IEEE 802.3 Interpretations Report

November 13th, 2003
Albuquerque, NM

Activities this week

Figure 38–5—Apparatus for generating receiver conformance test signal at TP3

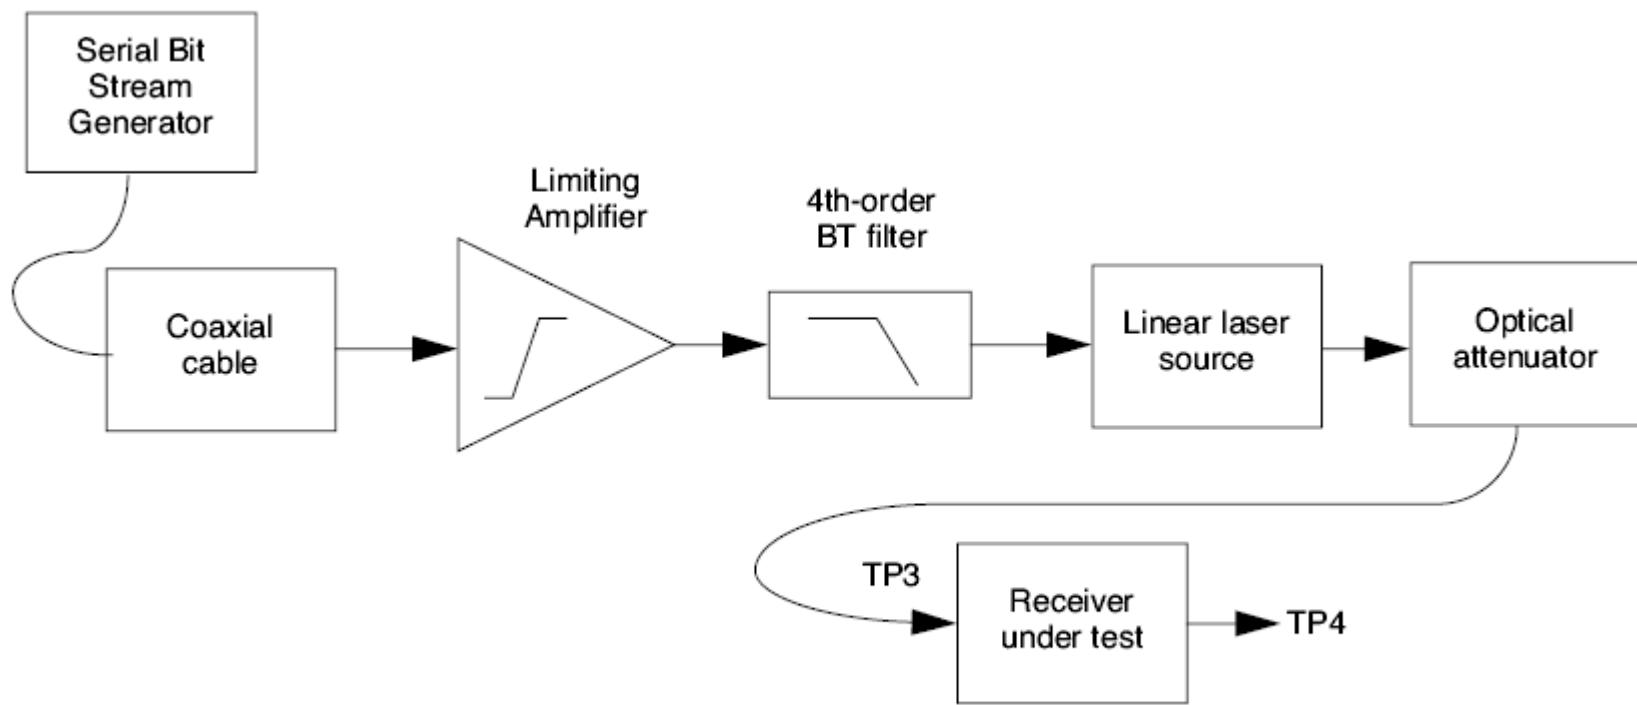
In the IEEE Std 802.3 2000 as well as 2002, in Section 38.6.11 "Conformance Test signal at TP3 for receiver testing", a 4th order BT filter is specified in the text and in Figure 38-5. We are in the process of building this test system and the vendors we are working with have stated that not enough information has been provided. Specifically, they have said that the BT coefficient of this filter needs to be specified. Can you provide this information to me? Also, a change to the standard may be in order to include this information.

The standard states in the penultimate paragraph of subclause 38.6.5 that 'A Bessel-Thomson filter is selected to produce the minimum ISI induced eye closure as specified per Table 38-4 for 1000BASE-SX and Table 38-8 for 1000BASE-LX.'

The functional test blocks, including the Bessel-Thomson filter, are intentionally not specified in detail in order to provide maximum flexibility in implementation.

What is specified instead is the behavior required. It is therefore essential that in a real world design without ideal components, the filter response be the response of the assembly of selected components used to implement the function.

The burden is therefore left on the implementer to select the filter such that the behavior, in conjunction with other real world components selected by the implementer, meets the requirements of the specification, specifically in the case of the filter '... the minimum ISI induced eye closure as specified per Table 38-4 for 1000BASE-SX and Table 38-8 for 1000BASE-LX.'

We believe that specification of the test set up is fully specified.
